## **SLAE Written Representation Submission for Deadline 9 - Construction**

This Written Representation reviews and comments on the five Construction titled documents.

### **TR020001-002894-5.02 Environmental Statement Appendix 4.1 Construction Method Statement and Programme Report**

*Inset 5.34: Airport Access Road (estimated cut & fill) Section 1a*

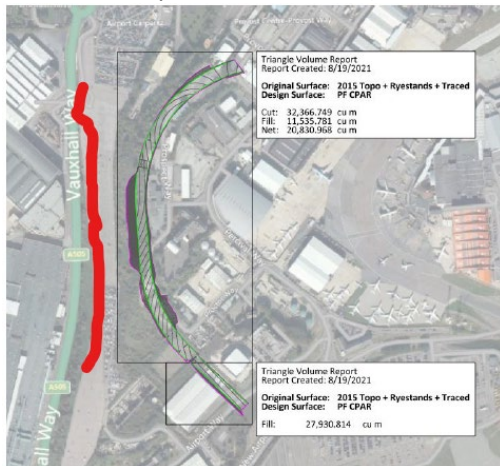
From the picture labelled as Inset 5.34 and then reading the activities associated with this section of the Airport Access Road, there seems to have been no risk assessment in any of the applicant documents for the possible subsidence of the embankment that is on the east (airport) side of the public A505, Vauxhall Way. SLAE indicate on the map in red where previous occasional subsidence has occurred on this road, normally as a result of weather conditions.

Also, could the vibration and work have involved with building the Airport Access Road cause subsidence?
